STATE OF TENNESSEE
DEPARTMENT OF ENVIRONMENT AND CONSERVATION
DIVISION OF REMEDIATION - DOE OVERSIGHT OFFICE
761 EMORY VALLEY ROAD
OAK RIDGE, TN 37830

TDEC Comment Letter

**Remedial Investigation/Feasibility Study for Comprehensive Environmental Response, Compensation, and Liability Act Oak Ridge Reservation Waste Disposal, Oak Ridge, TN
DOE/OR/01-2535&D3
March 2015**

Document Name: *Remedial Investigation/Feasibility Study for Comprehensive Environmental Response, Compensation, and Liability Act Oak Ridge Reservation Waste Disposal Oak Ridge, Tennessee Operations Plan, Oak Ridge, Tennessee (DOE/OR/01-2535&D3)*

Figure 2: Conceptual model for contaminant migration in Bear Creek.

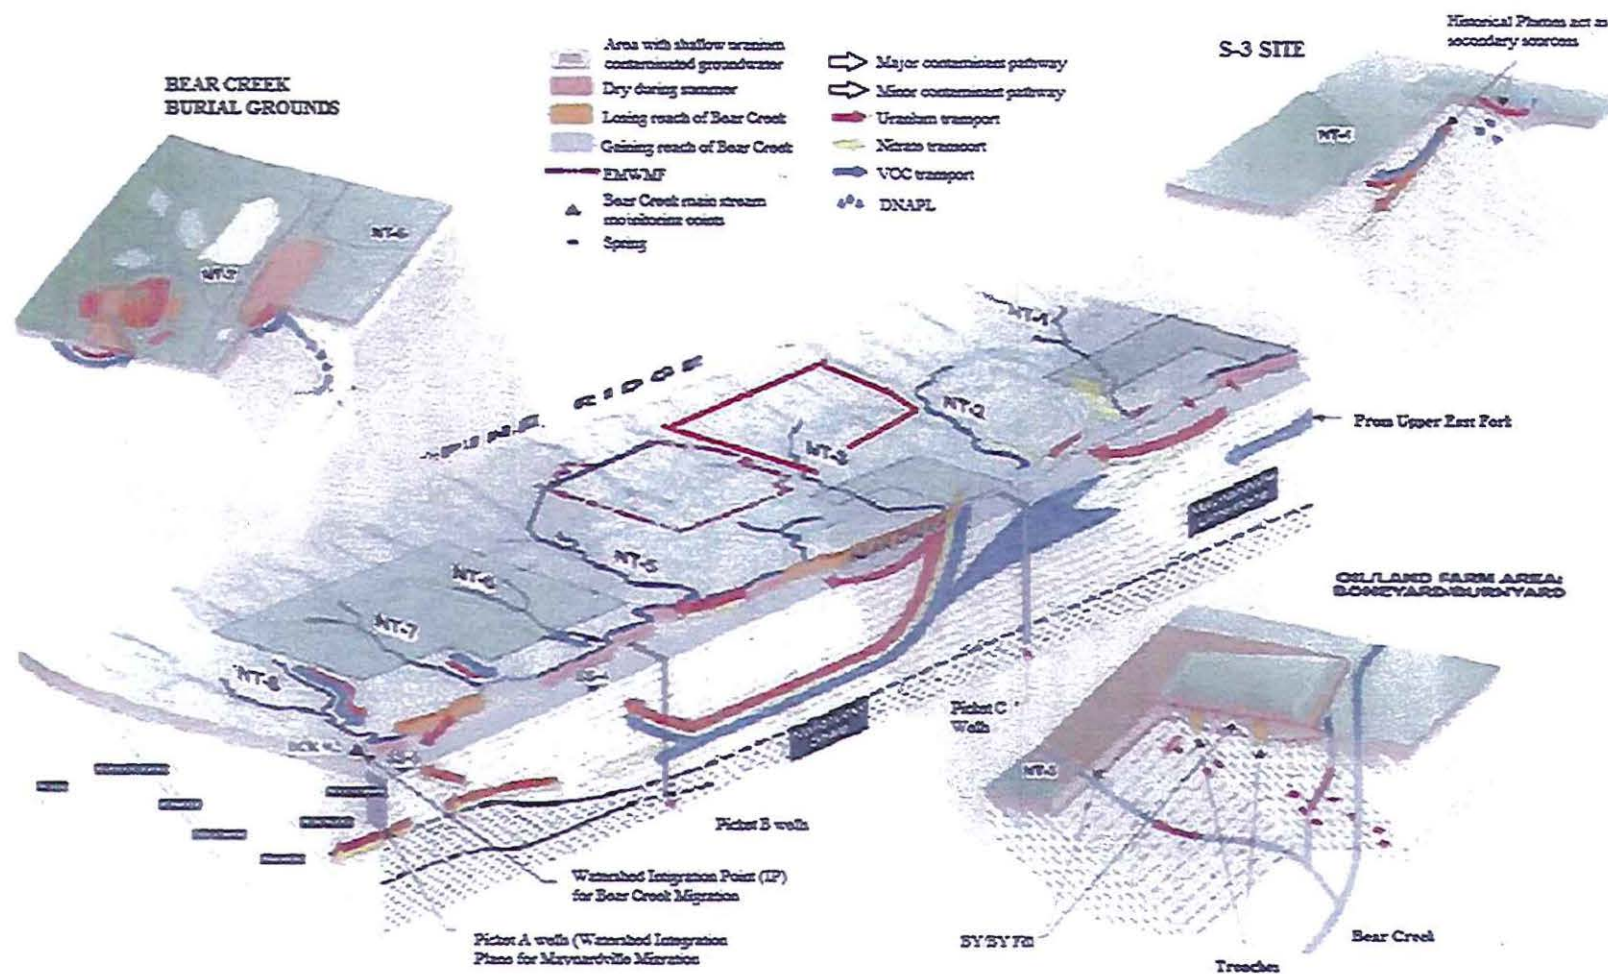
As NT-3 flows southwesterly underneath cells 1 through 3, NT-2 drains the eastern cells (5 & 6), and the proposed underdrain is designed specifically to capture groundwater beneath the cells and deliver it to these streams, any contaminants released from the facility would be expected to disperse rapidly to both surface and ground waters and be transported downstream by way of Bear Creek to Poplar Creek and the Clinch River.

Figure 6: Location of primary waste disposal areas in Bear Creek Watershed. (Basemap from *Focused Feasibility Study for the Bear Creek Burial Grounds at the Y-12 National Security Complex, Oak Ridge Tennessee*.¹⁹

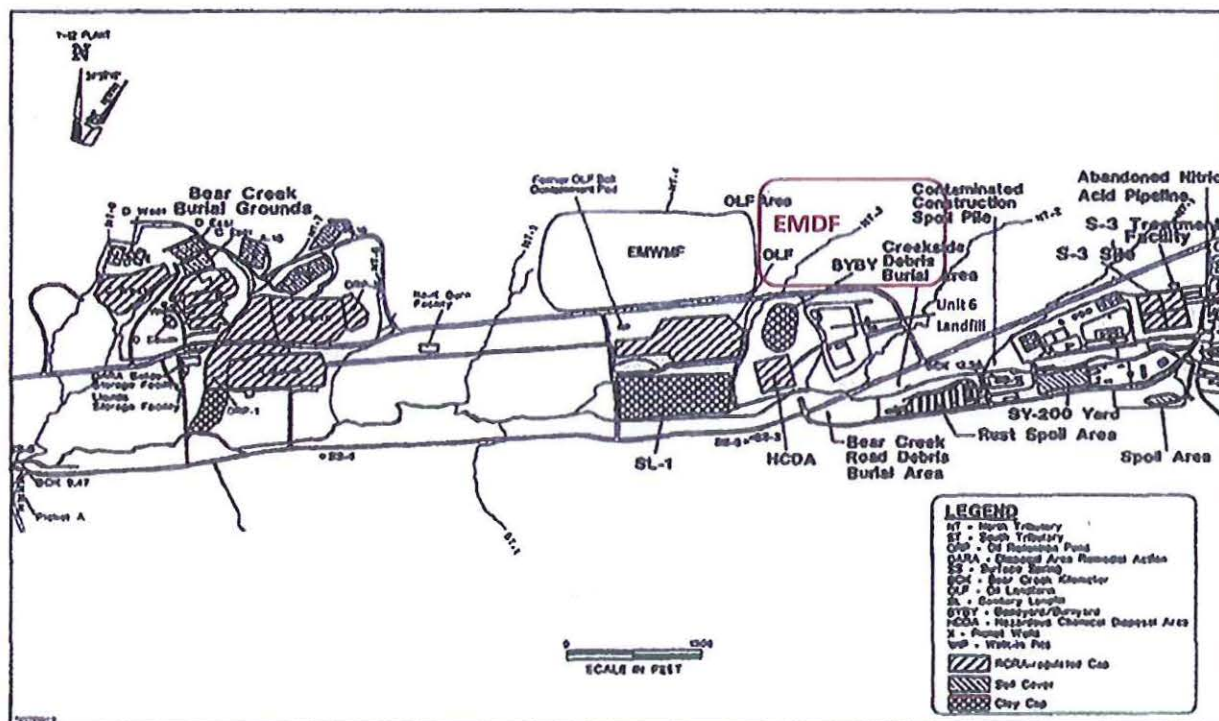
The EMWMF and seven legacy disposal sites are located immediately adjacent to or in close proximity to the proposed EMDF location (Figure 6): the EMWMF immediately to the west; the Oil Land Farm (OLF) and Sanitary Landfill 1 to the southwest along the western bank of NT-3; and Boneyard/Burnyard (BY/BY), the Hazardous Chemical Disposal Area (HCDA), and the Unit 6 Landfill immediately to the south along the eastern bank of NT-3. Approximately 3,000 feet further east are the S-3 ponds and approximately 4,000 feet to the west are the Bear Creek Burial Grounds.

Figure 7: Extent of groundwater contamination in Bear Creek Valley. Basemap reproduced from *Characterization to support Watershed-Scale Decision making for the Bear Creek Watershed at the Oak Ridge Reservation, Oak Ridge, Tennessee* (Moss et al, 1999).²¹

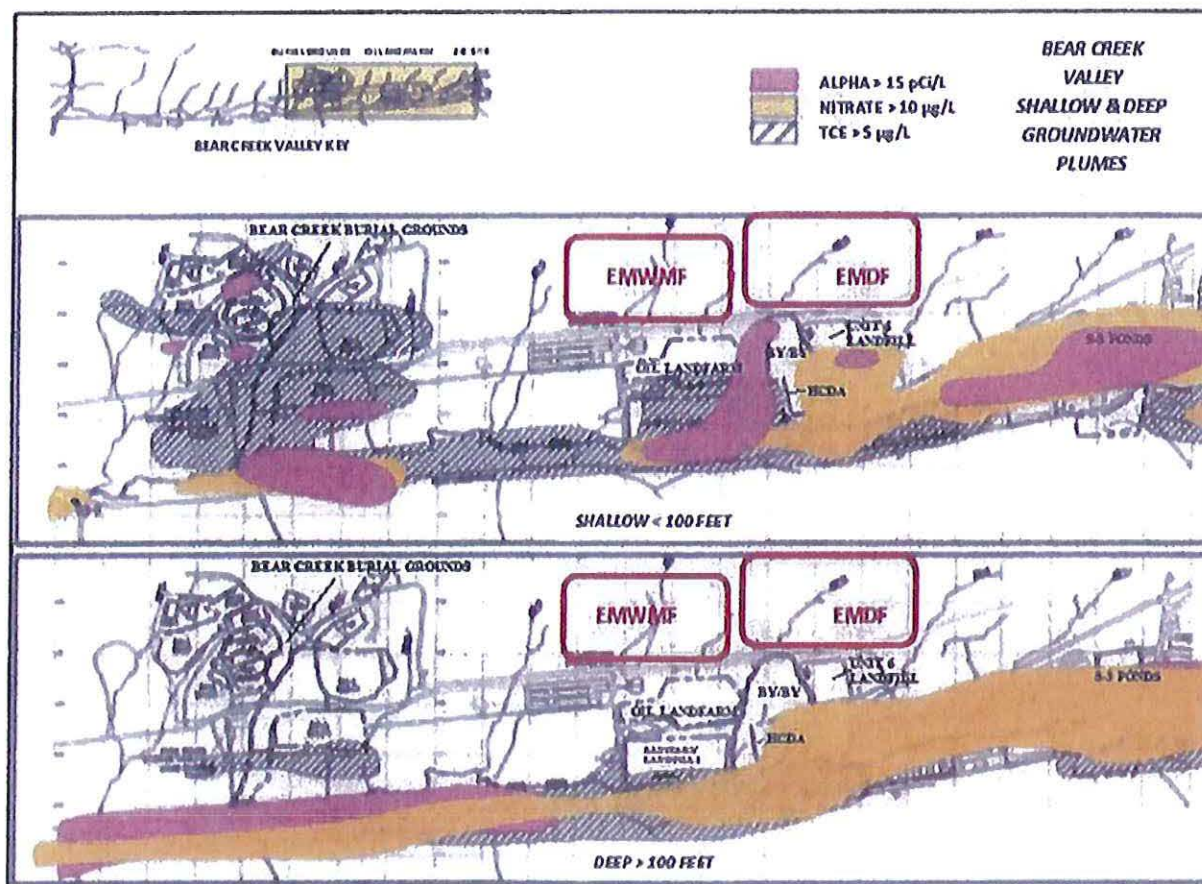
Releases from the legacy disposal sites have formed a comingled plume containing multiple contaminants that extends from the S-3 Ponds to the east down the valley parallel to Bear Creek past the Bear Creek Burial Grounds. The plume passes directly in front of the proposed EMDF site and contaminants are evident in NT-2, NT-3, and Bear Creek below the site (Figure 7). The 2014 Remediation Effectiveness Report (RER)²⁰ indicates the uranium concentrations have been rising in NT-3 in recent years, although the exact source of the contamination is uncertain. In 2013, the flux of uranium in the stream was approximately five times the goal in the ROD for Phase 1 Activities in Bear Creek Valley and comprised approximately 16% of the total uranium flux at the Bear Creek integration point (which was ~ 3.6 times the goal set in the ROD). Releases from the legacy disposal sites have the potential of masking any releases from the EMDF. Alternately, any releases from the EMDF would contribute to exceedances of the goals set in the ROD for NT-3 and the Bear Creek Integration Point. It should also be noted that while the concentrations of total mercury in NT-3 reported in the RER were below AWQC, methylmercury concentrations were higher than any other location monitored on or off the ORR.

Figure 8: Streams, Wetlands, and Reference Areas in Vicinity of the proposed EMDF. (Reproduced from D2 RI/FS Figure C-17)

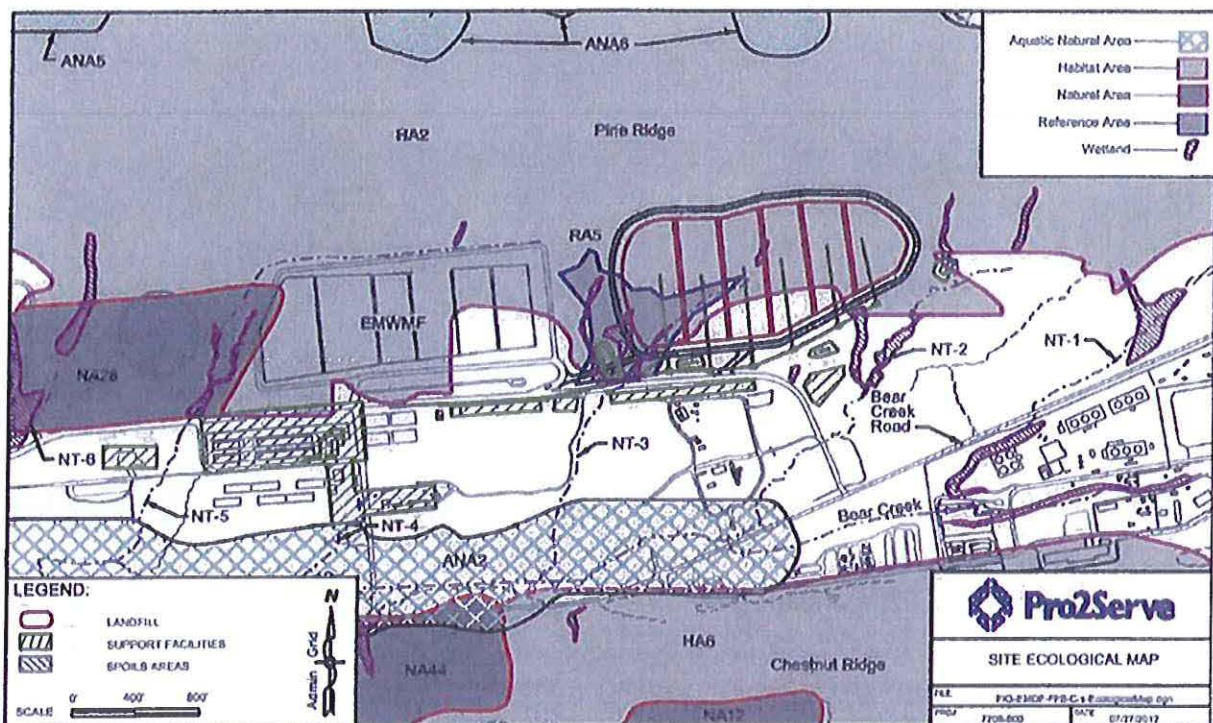
The footprint of the EMDF would cover a number of wetlands, zones, of upwelling groundwater, and draws & ravines containing seeps and springs (Figure 8). According to the RI/FS there are six wetlands in the NT-3 drainage. Five wetlands are included in Reference Area (RA)-5, the Quillwort Temporary Pond wetland. RAs are defined as primarily terrestrial areas that contain special habitats or features and that also may serve as reference or control areas for research, monitoring, remediation, or characterization activities. A small emergent wetland occurs farther upstream on NT-3 from RA-5.

Figure 10: EMDF Underdrain System. (Reproduced from Figure 6- 8 of the D2 RI/FS)

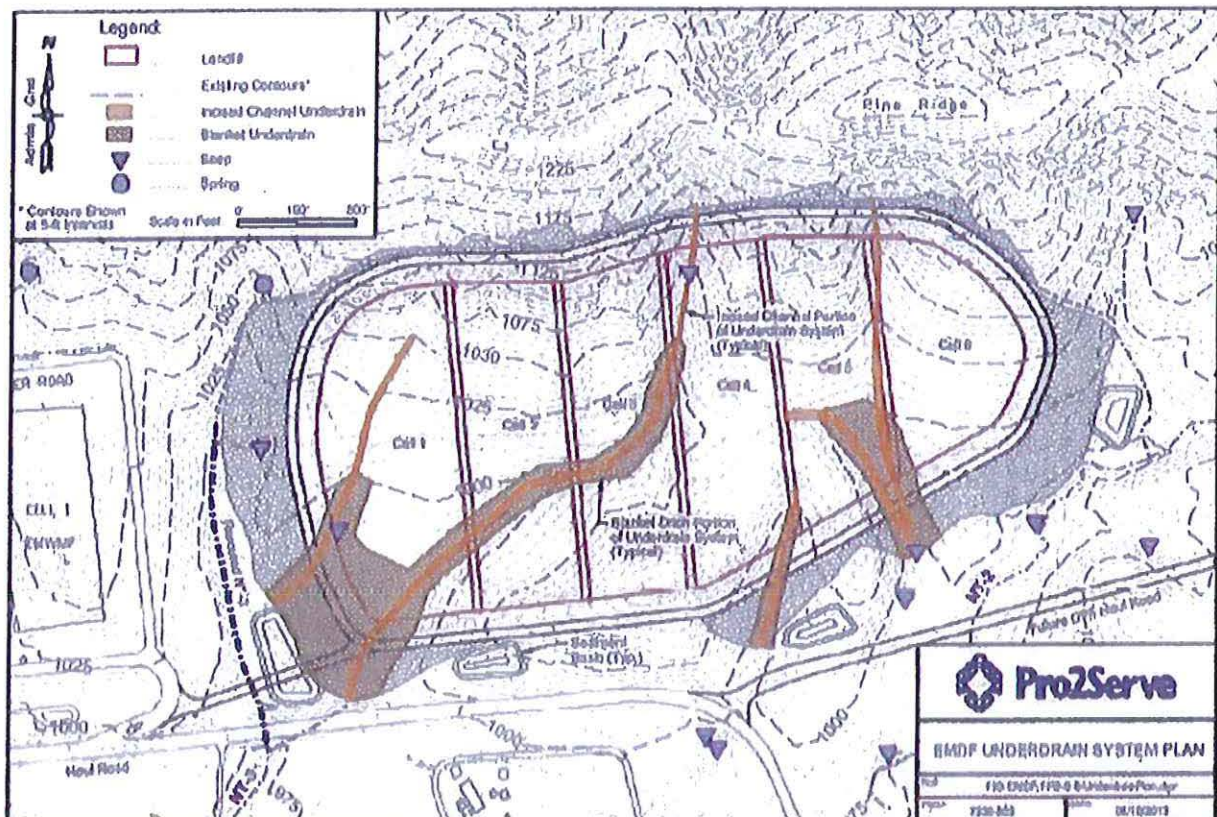
To control storm water from the steep slopes above the facility and capture uncontaminated groundwater to help lower the water table and minimize underflow towards the liner, the RI/FS proposes a geomembrane lined rip raped ditch with an underlying French drain (comprised of gravel wrapped geotextile filter fabric) extending ten feet below the surface to collect groundwater and discharge it the ground surface down gradient of the facility. To maintain the water table below the base of the landfill liner system, a portion of the NT-3 tributary would be filled and an extensive underdrain system constructed to provide a flow path for groundwater immediately below the landfill within the portion of NT-3 to be filled and beneath the landfill locations where there are wetlands, draws, and ravines containing springs and seeps, with the intent to intercept potentially upwelling groundwater and prevent it from rising into the geologic buffer (Figure 10). It is unclear how the underdrain would be maintained or repaired should it fail (e.g., clog) over the course of hundreds of years, considering it would be covered by 2.5 million yards of radioactive and hazardous waste, much of which would have been created by mixing clean soils with debris to maintain the soil to debris ratio.
